Serial: BSEP 13-0009

Subject: Brunswick Steam Electric Plant, Unit Nos. 1 and 2
Docket Nos. 50-325, 50-324, 72-006
Revision to Radiological Emergency Response Plan

1. Radiological Emergency Response Plan (OERP), Revision 82

Figure 2.0-1
Response Sequence to Off-Normal Conditions
Page 1 of 1

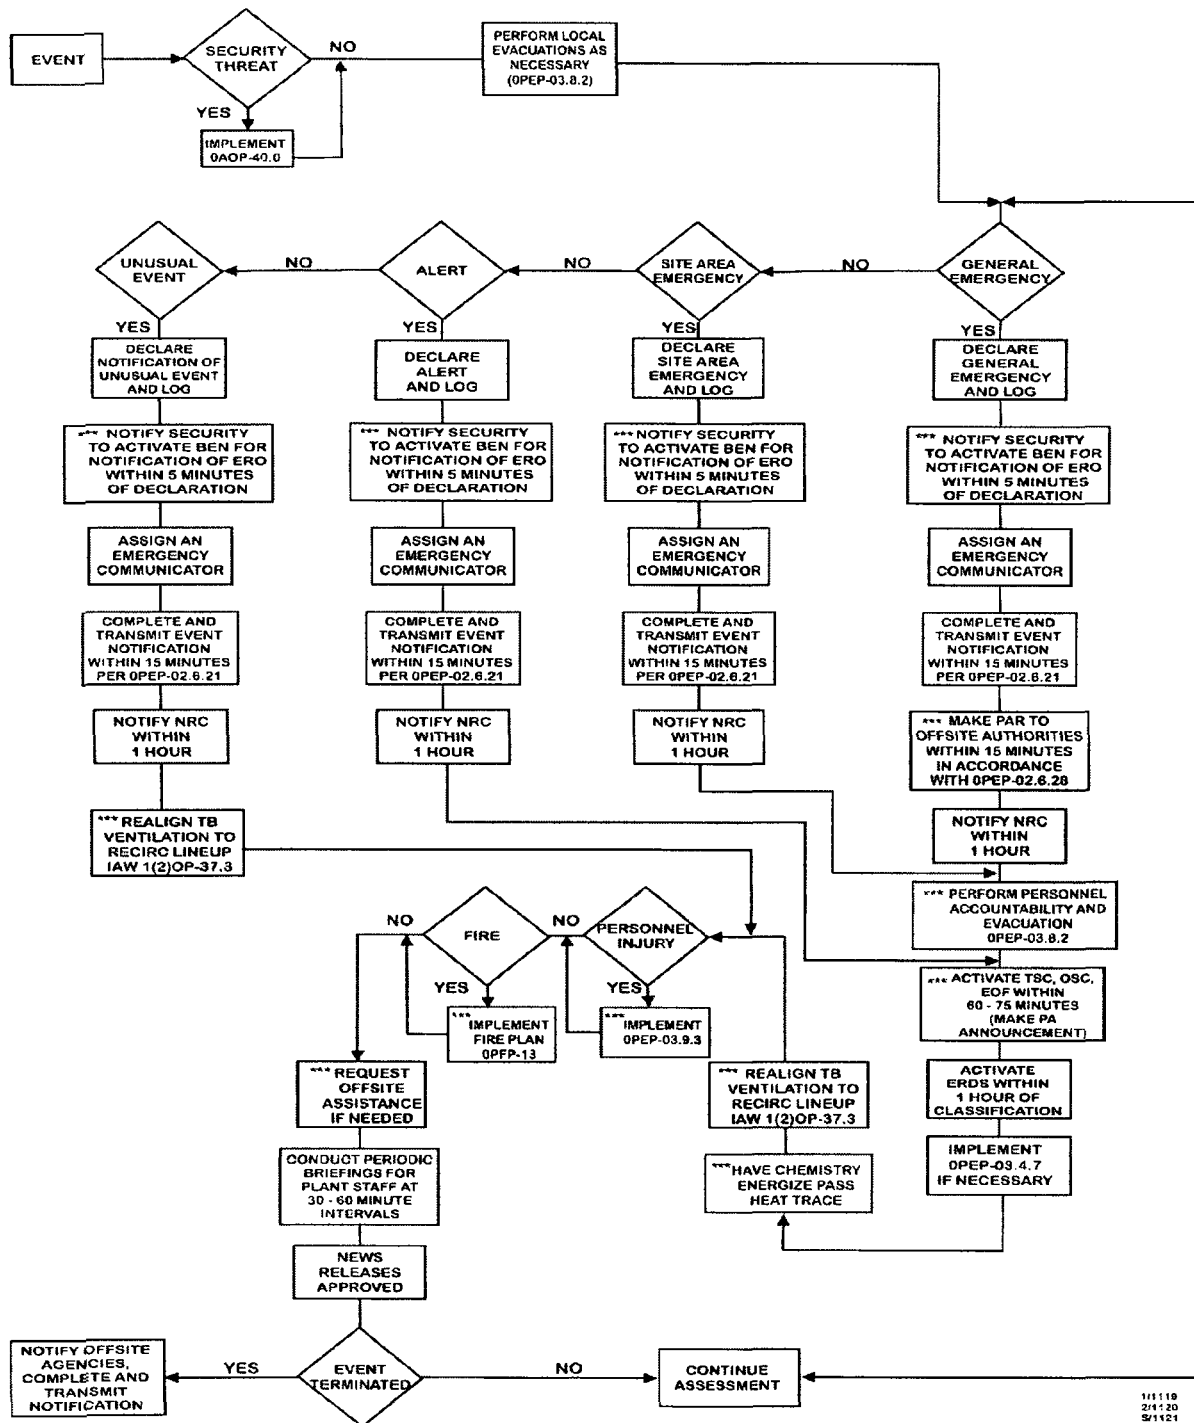
- Updated a figure from a simple flow chart to a more detailed flow chart describing Control Room emergency response actions associated with each emergency classification (i.e., Unusual Event, Alert, Site Area Emergency, and General Emergency). This change also includes a block describing a Security Threat.

- Section 2.1, General Classification System, page 2-1, first paragraph, 2nd sentence, changed the word "instructions" to "procedures." PRR 572687
- Figure 2.0-1, Response Sequence to Off-Normal Conditions, page 2-6, was updated to provide more detail and include Security Threat. PRR 572687
